September 11, 2007

L-2007-144  
10 CFR 50.4  
10 CFR 50.55a

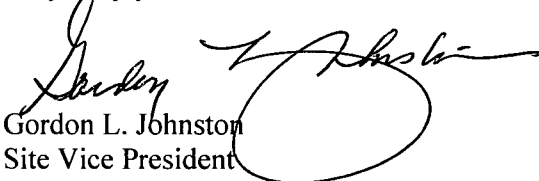
The fourth ten-year in-service-test (IST) interval for St. Lucie Units 1 and 2 begins on February 11, 2008 and ends on February 10, 2018. Pursuant to the provisions of 10 CFR 50.55a(f)(4)(ii), the enclosed program outlines the IST plans for St. Lucie Units and 2 based on the requirements of the American Society of Mechanical Engineers (ASME) OM Code 2001 Edition through 2003 Addenda (ASME OM Code 2001/2003a). The IST program plan includes Mandatory Appendix II of the ASME OM Code 2001 Edition through 2002 Addenda (as modified by 10CFR50.55a(b)(3)(iv)(A), (B), and (D)) for check valve condition monitoring activities.
